MODEL
XK, XJ,
S-TYPE

NUMBER
JTB00034

TECHNICAL BULLETIN

Noise when Turning Steering Wheel

Figure 6

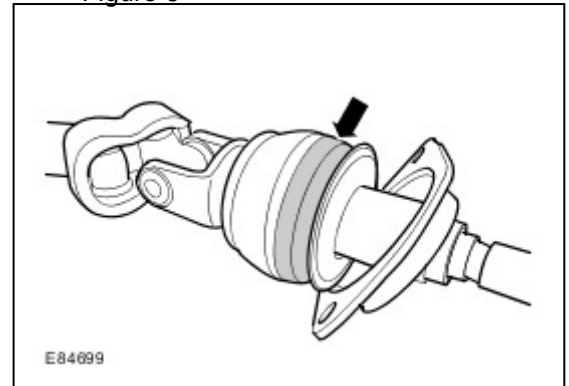
5. Check condition of the lower knuckle joint.
6. If there is a fault with the knuckle, repair the fault
7. Slide back the steering column retaining plate to gain access to the retaining plate rubber.
8. Grease the retaining plate rubber using two packs of KSP205 from the Squeaks and Rattles Kit (JLM21204). (Figure 6)
